Reply to the Reviewer #2

The reviewed manuscript presents a study aimed at developing an affordable computational fluid dynamics (CFD) method using Reynolds-averaged Navier-Stokes (RANS) simulations to accurately predict aerodynamic noise from wind turbine rotors. Addressing rotor noise is a topic of great significance, as reducing rotor-generated noise can minimize turbine curtailment and increase Annual Energy Production (AEP). However, the manuscript requires several improvements to enhance clarity, address inconsistencies, and strengthen the analysis and discussion.

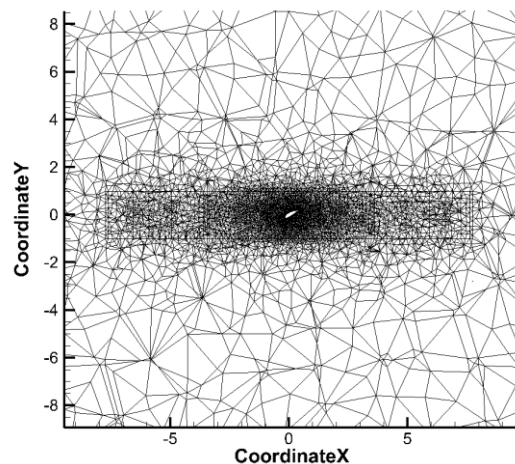
1. The use of a 10m cell mesh raises concerns regarding the transferability of the previous mesh convergence study. The authors should address this issue and explain the rationale behind the selected mesh size.

Authors Reply: An unstructured inviscid mesh with 3.6 million tetrahedral cells clustered around the blades and tip vortices was created in the reference (Sezer-Uzol, N et al., 2009). In the reference, a total mesh of 9.6 million tetrahedral cells clustered around the blades and tip vortices was created for LES model in the whole domain and similar to the simulations in this paper (10m). The extra meshes are located outside the computational domain and do not affect the simulation results of the flow field near the wind turbine based on the reference. Detail 10m cells can be seen in the figure below. We added some discussion in Problem description section.
